**Contract No. 99771**

**Revised Submittal**

**New Bedford Main Line**

Re: DEP File No. SE 049-0805  
Revised Notice of Intent: South Coast Rail – New Bedford Main Line NOI  
New Bedford, Massachusetts

### Lined Bioretention Basin W/ Underdrain

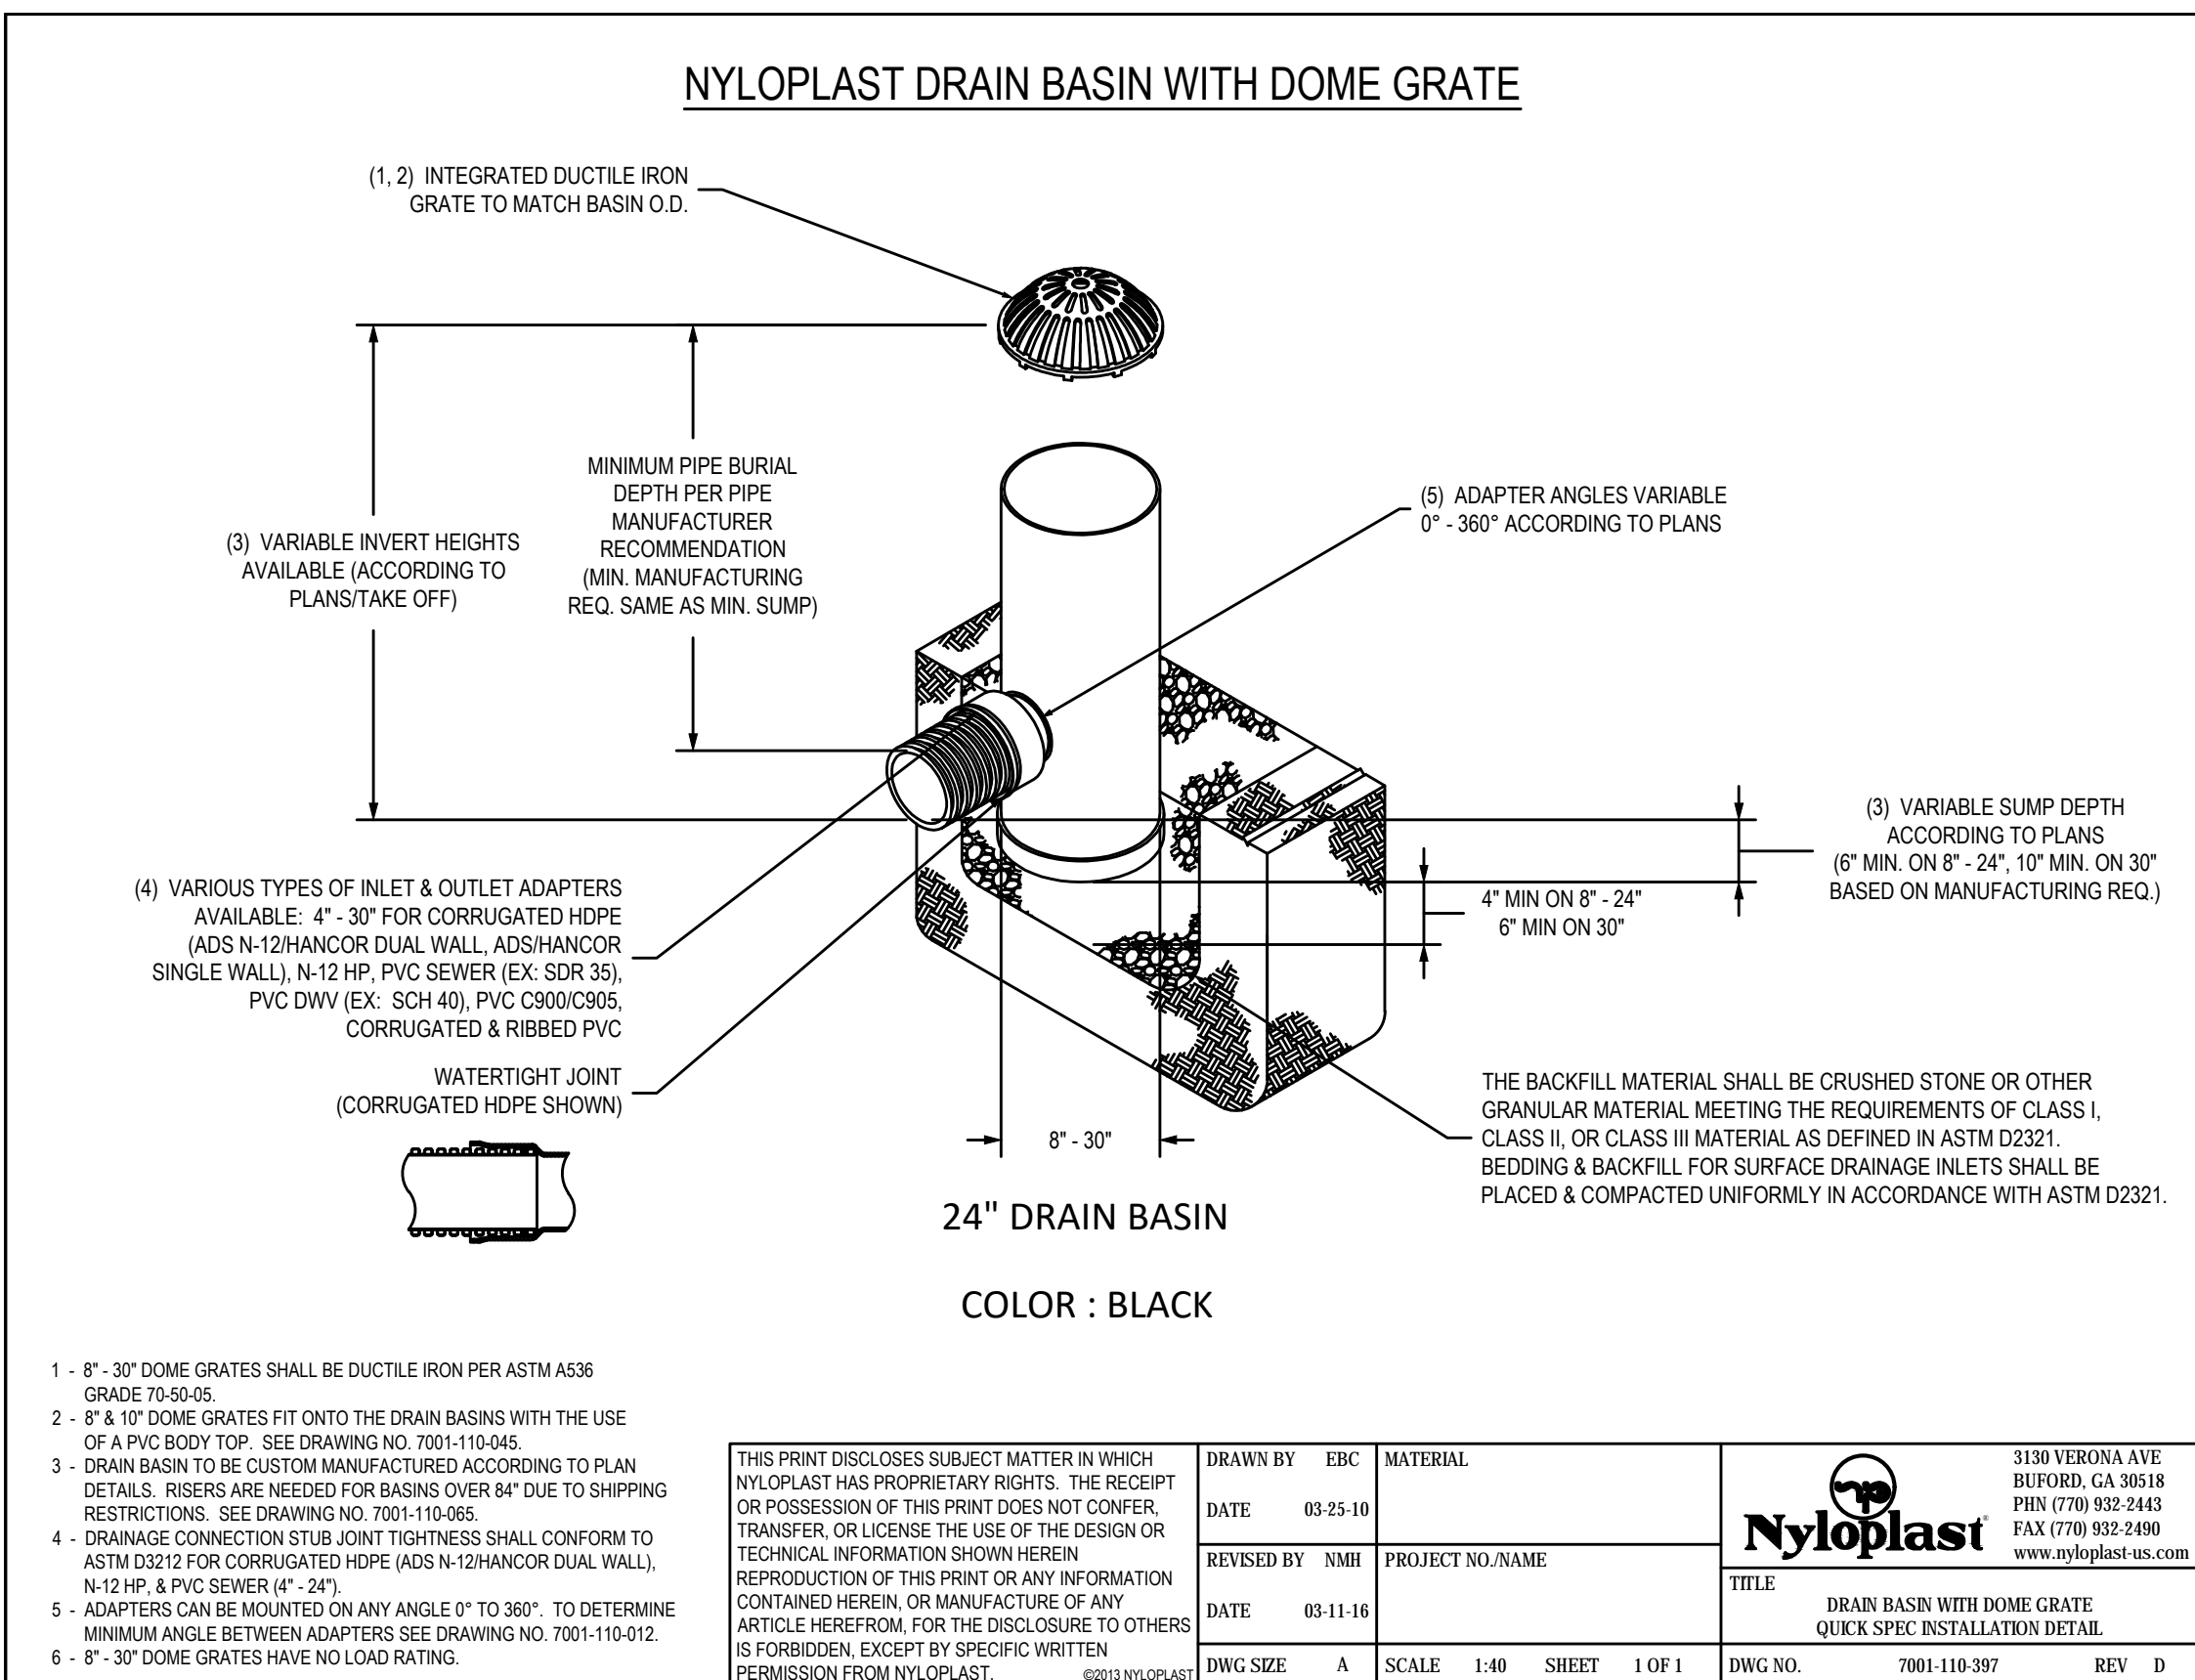
Nitch	Bioretention basins should show a foot of freeboard for all storms. Both bioretention basin 1 and 2 do not meet this requirement for the 10-year and 100-year storms. The Guidelines require a foot of freeboard in bioretention basins.	The top edge of Bioretention Basin 1 has been raised to 7.5'. This provides 8.5 inches of freeboard in the 100-year storm, which is adequate for 6" of ponding. The top edge of Bioretention Basin 2 has been raised to 10.8, providing over 12 inches of freeboard in the 100-year storm.
Nitch	The HydroCadd calculations show the stone overflow elevation at 9.5. They also show the bottom of the forebay at elevation 9.5, effectively indicating that there is no berm between the sediment forebay and the bioretention basin.	Low Flow Sediment Forebay Berm invert elevation has been raised to 10.0.
Nitch	The detention basin underdrain detail shows the crushed stone surrounding the underdrain to be brought to the bottom of the bioretention basin. The bioretention basin shows the under drain sitting in a 12-inch stone bed. We agree with the under drain shown in the bioretention basin detail.	Yes, the underdrain should be installed at the bottom of the stone bed. The detention basin underdrain detail has been removed from the plans.

### Stone Diaphragm Pretreatment Filter Strip

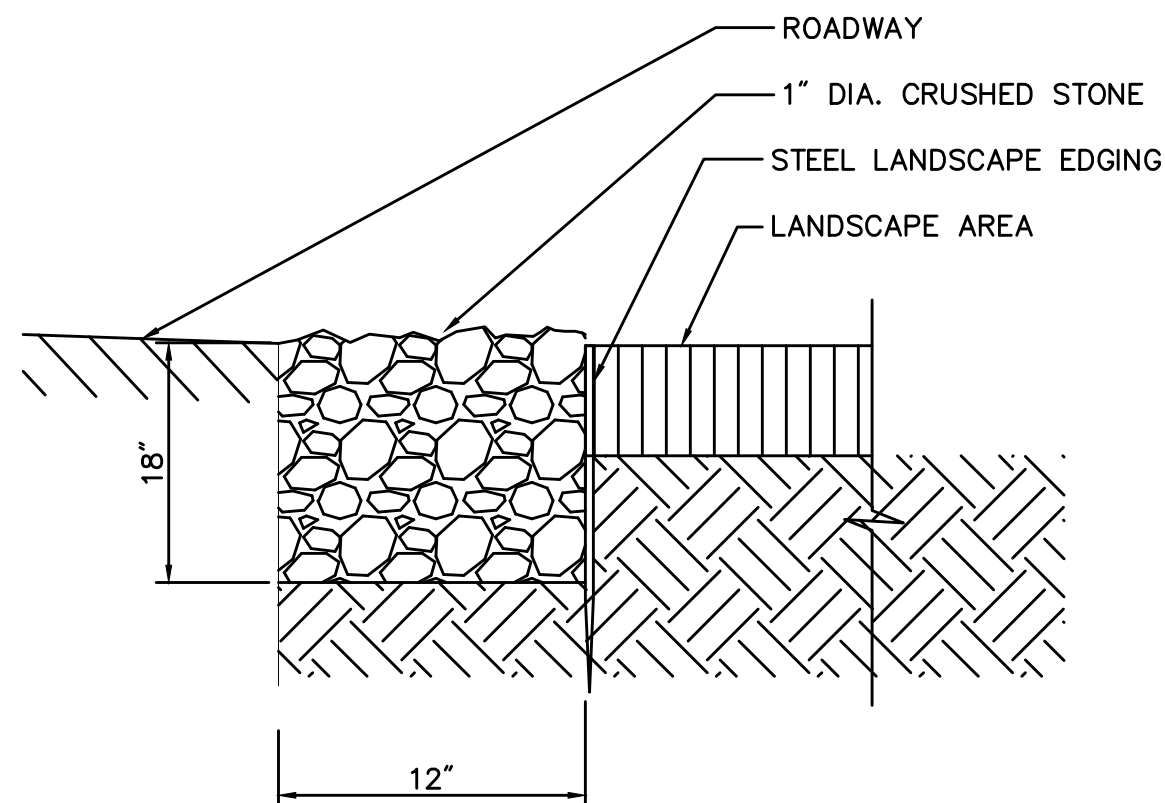
Nitch	The detail sheets include a Stone Diaphragm Pretreatment Filter Strip detail. It is unclear where this is proposed.	Revised Sheet CV-311 is included with this resubmitted with the detail for the Stone Diaphragm Pretreatment Filter Strip removed, since it is not proposed for this project.
<b>Nitsch Engineering, Inc. - Whale's Tooth station</b>		
Nitch	The piping from the platform canopy is shown as reinforced concrete pipe. The HydroCadd model shows this piping as PVC. The plans show this pipe's slope at 8% while it is modeled at 4.8%. The plans show 48 feet of pipe and the model shows 83 feet. The plans and model should be consistent.	The HydroCAD model has been updated to match the CAD.
Nitch	We recommend a minimum Time of Concentration of six minutes be used consistent with TR-20.	The HydroCAD models have been updated for a Time of Concentration of 6 minutes.
Nitch	We recommend the weir overflow elevations be depicted on the plans consistent with the HydroCadd calculations.	Weir overflow invert elevations have been added to the plans for clarity.

NEW BEDFORD MAIN LINE  
WHALE'S TOOTH STATION  
GRADING AND UTILITY PLAN

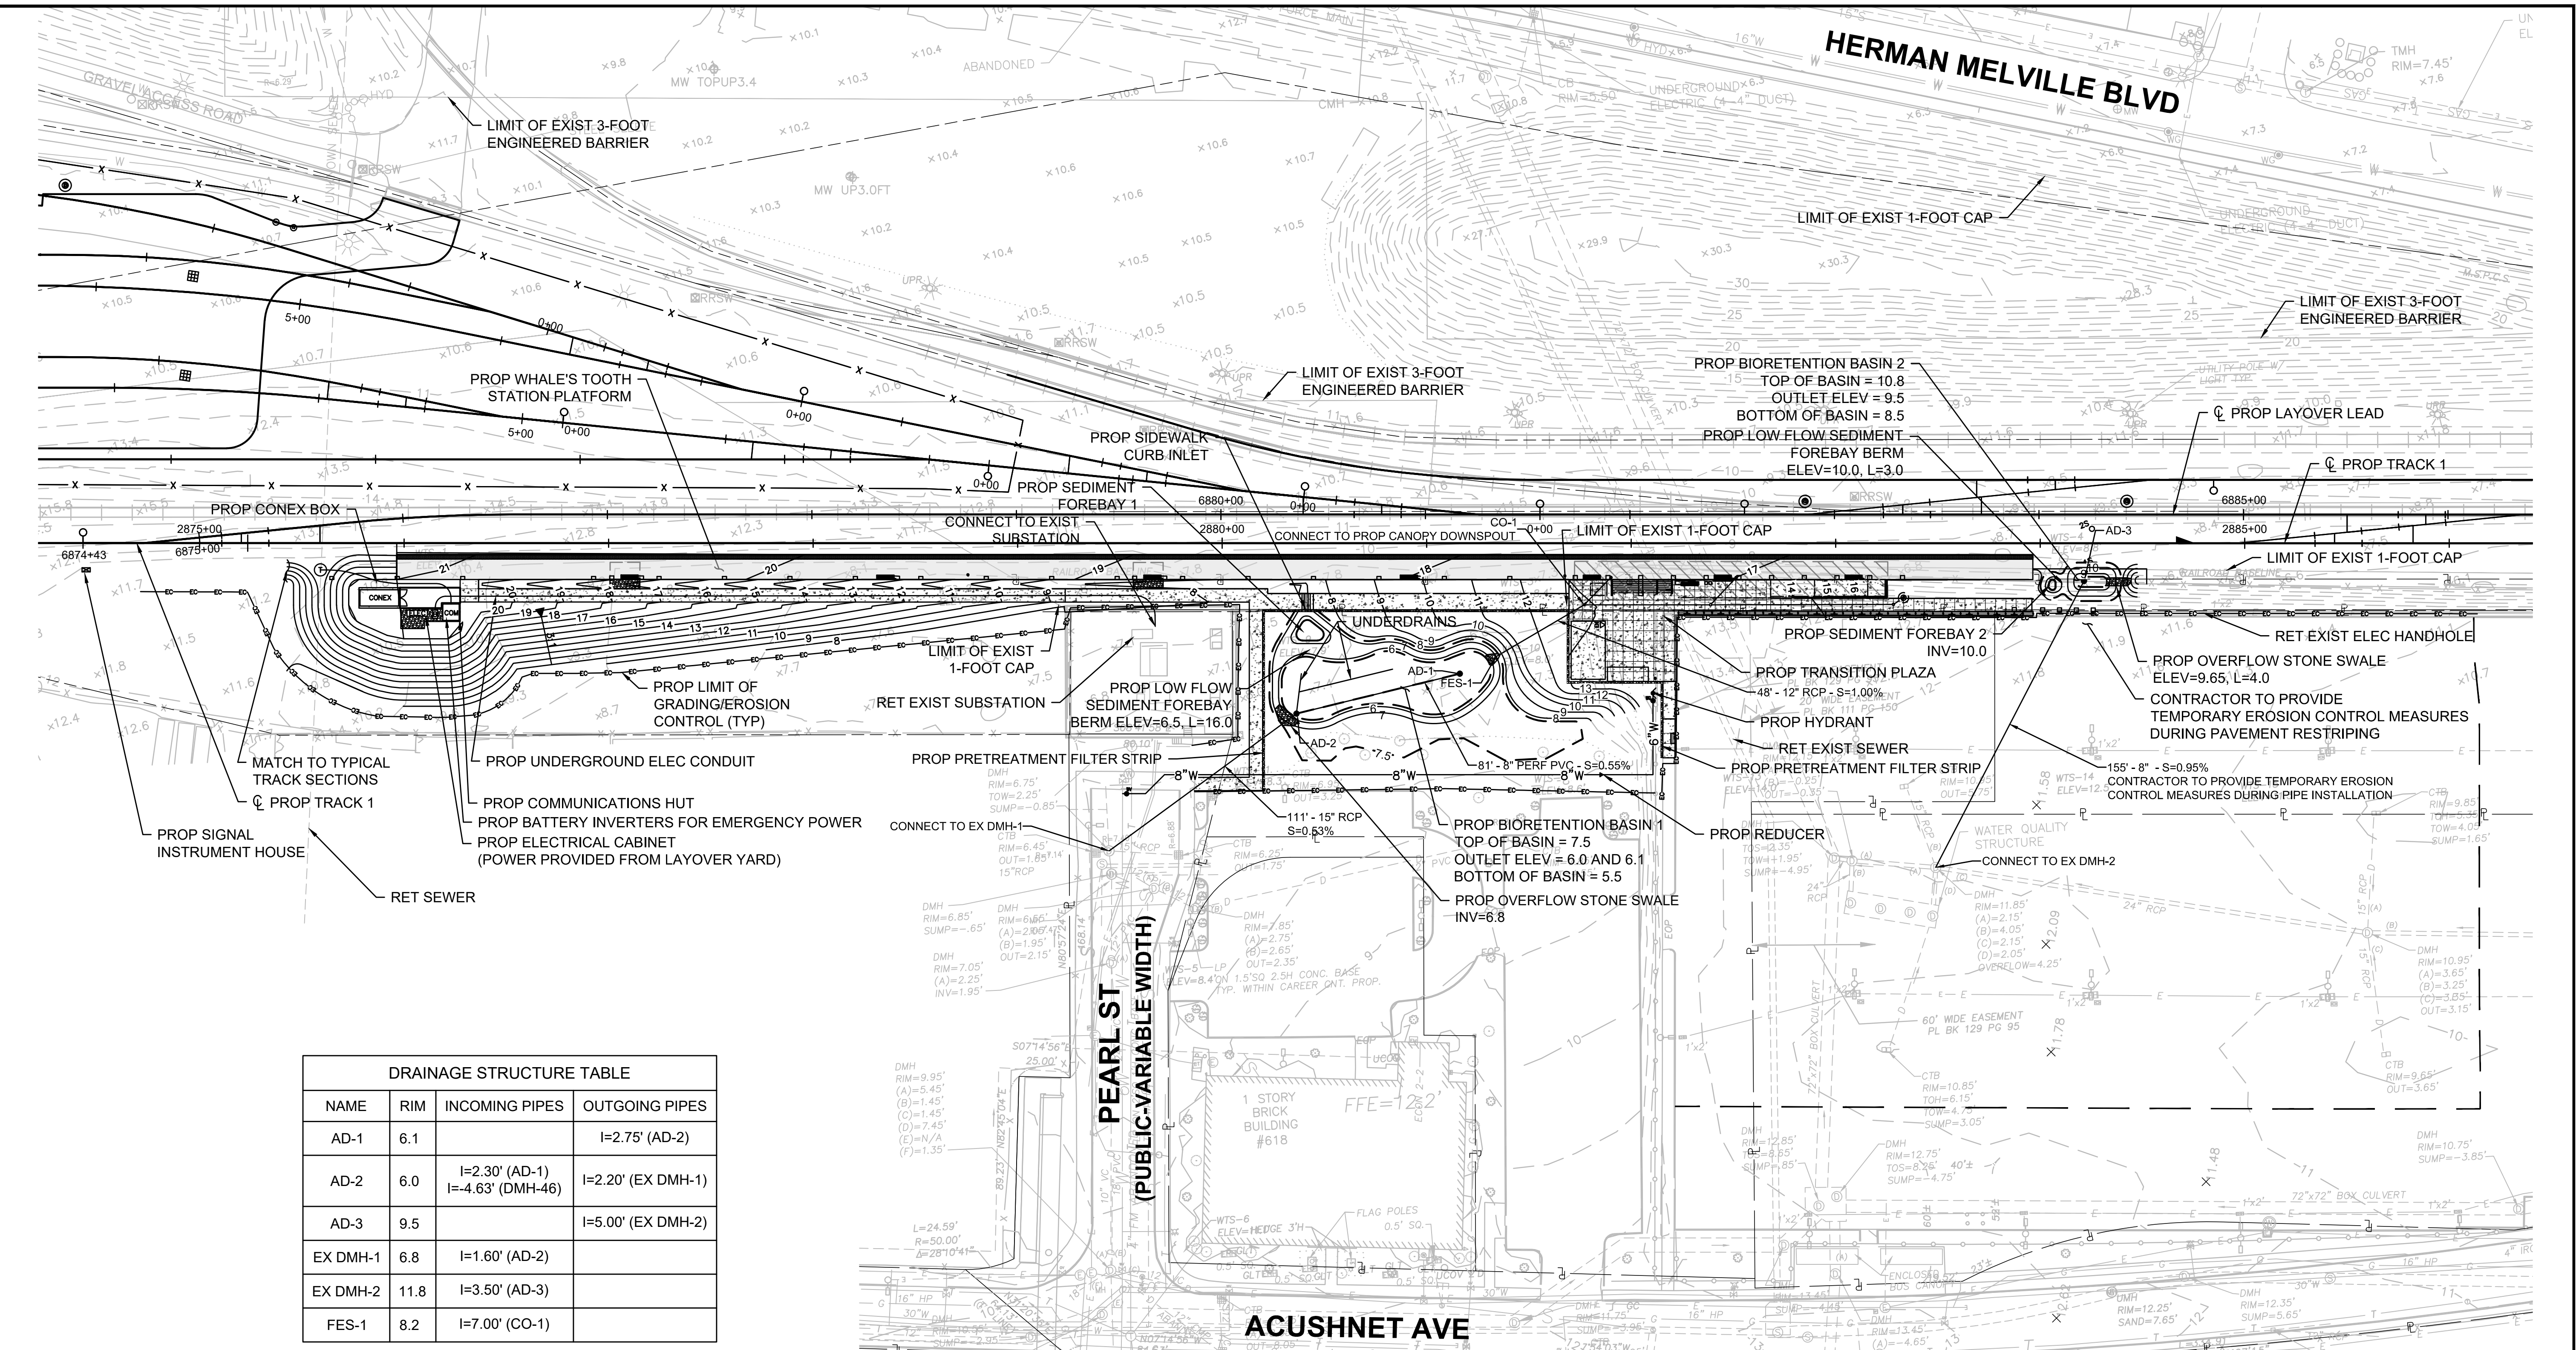
Nitch	The bioretention basin 1 design shows the bottom of the basin at elevation 2.5. Existing grade in this area is approximately 7.3. It is unclear whether the excavation will intrude upon the cap. It is also unclear what groundwater elevations are in this area.	The Bioretention Basin lies outside the limit of the existing soil cap area on the site. The basin will be lined to prevent groundwater from entering the basin, and to prevent stormwater from infiltrating into the ground. Per test wells WTS-11 and WTS-12 at Bioretention Basin 1, groundwater elevation is at -0.7 and 0.6, respectively. Per test well GTSB-EA-23 at Bioretention Basin 2, groundwater elevation is 5' below the surface. For both basins, the groundwater elevation is below the bottom of the facility.
Nitch	A Stormwater Pollution Prevention Plan (SWPPP) was not provided for review.	The contractor will be required to prepare and implement the SWPPP. The contractor will provide a copy to the commission prior to construction. We recommend a condition stating thus, consistent with special condition # 51 from the Wamsutta order of conditions.
